STAFF REPORT AMENDED 1-10-85  
CITY PLANNING COMMISSION

- APPLICATION:
- A. Negative Declaration
  - B. Special Permit to locate required maneuvering area and driveway for a proposed parking lot in the Single Family (R-1) zone.
  - C. Variance to reduce the 50% shading requirement to 10%.

# CITY PLANNING COMMISSION

**APPLICATION:** A. Special Permit Modification of an existing parking lot layout  
B. Variance to waive six foot high masonry wall

**EXHIBIT A**  
**SITE PLAN**

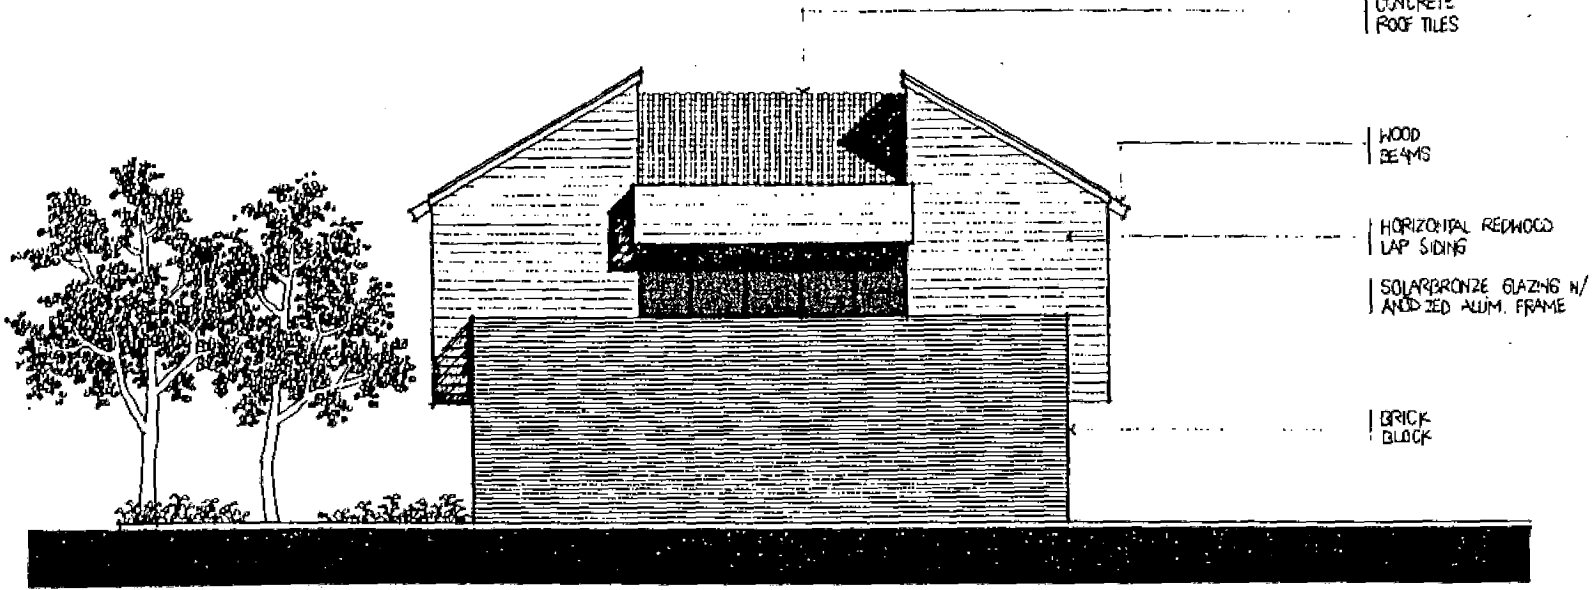
- C. According to the applicant's site plan, approximately 10% shading of the parking lot can be provided. The Zoning Ordinance requires 50% shading. The applicant is therefore requesting a variance from this requirement. This reduced shading can be justified, in that the property is narrow and is difficult to develop with a split zone and with an adjacent single family use. The parking spaces and structure were located to the north of the property (C-2 zone) to reduce the impact onto the adjacent residence to the south. This design therefore reduced the required planter width for large trees along the south property line. However, adequate landscaping will be provided on the remaining portion of the site.

- D. Staff has no objections to the applicant's request; however, the following modifications are suggested:
1. A six-foot high decorative masonry wall will need to be constructed along the south property line and the west property line;

2. The trash enclosure must be constructed to the standards set forth in Exhibit C;
  3. A landscape strip should be extended along the entire length (50 ft.) of the west property line of the subject site.

1. *A six-foot high decorative masonry wall shall be constructed along the south property line and the west property line. The wall design shall be reviewed and approved by the Planning Director prior to issuance of a building permit. Applicant shall obtain a Planning Director's variance to waive the masonry wall requirement (CPC amended)*
2. The trash enclosure shall be constructed to the standards set forth in Exhibit C.
3. The landscape strip along the west property line shall be extended to the south property line.

4. A revised landscape/shading and irrigation plan shall be submitted to staff for review and approval prior to the issuance of building permits.

**EXHIBIT A**  
**SITE PLAN**

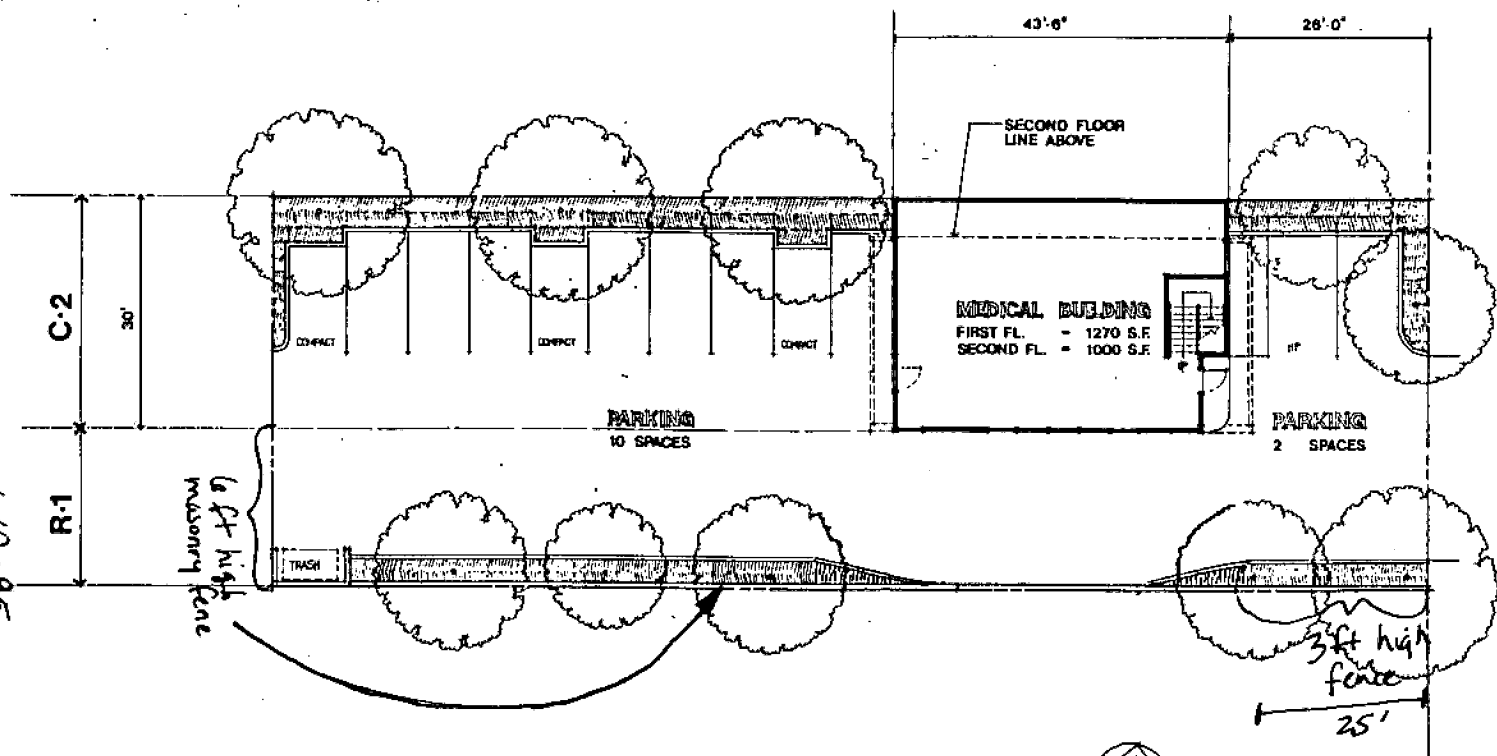
- B. The applicant is proposing to construct a one-story, 2,400 square foot office building and parking lot on the C-2 portion of the lot. The original application (see attached staff report) called for a two-story office and parking lot. The original application was approved with the building on the front of the lot and the parking at the rear. The applicant requests that the original special permit be modified to reflect the new site layout. This would place the parking at the front of the lot where it would have less impact on surrounding uses.

In addition, the applicant is requesting to waive the six foot high masonry block wall along the south property line between the parking lot and the residential use to the south. The adjacent property owner has indicated that they prefer a lattice fence with landscaping to the six foot high solid wall. The applicant is also concerned that the existing shrubbery along the south property will not survive the excavation for the wall foundation.

1. Driveway must be 26 feet wide.
  2. The 'vine covered wall' must end before 10 feet from sidewalk for driveway visibility.
  3. Street trees cannot be accommodated properly in four foot wide planters.
  4. No turning space is provided for the rear compact stall.
  5. If the neighbor to the south has a driveway along this property line, the parking area must be reversed to provide proper spacing between driveways.
- D. A portion of the trellis along the south side of the office building projects into the required 15 foot rear yard setback by 10 feet. This portion of the trellis will need to be eliminated to comply with the R-1 setbacks.

1. The driveway shall be constructed to City standards and shall be approved by the City Traffic Engineer.

2. The trellis along the south side of the proposed building shall comply with the rear yard setback for the R-1 zone.
3. The 'vine-covered' wall must end 10 feet from the edge of the sidewalk for driveway visibility.
